## Hi-Fi Products Service Bulletin

Model: D-335, TCD-D7 No. 419

**Subject:** No Digital Recording **Date:** December 27, 1994

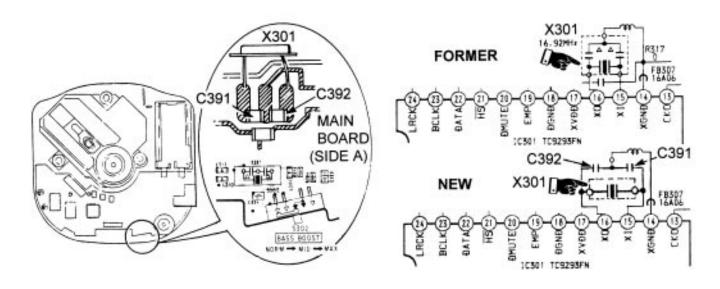
(55) Digital recording is impossible when connecting D-335 to TCD-D7 using an optical

connection cable.

**Solution:** Apply the following changes on the Main Board of D-335.

1. Replace the Ceramic Oscillator X301 with a Crystal oscillator.

2. Add 2 capacitors.

REF	FORMER		NEW	
	DESCRIPTION	PART NUMBER	DESCRIPTION	PART NUMBER
X301	CERAMIC OSCILLATOR	1-760-404-11	CRYSTAL OSCILLATOR	1-567-908-11
C391/ C392	-	-	15PF/50V CERAMIC CHIP CAPACITORS	1-162-917-11
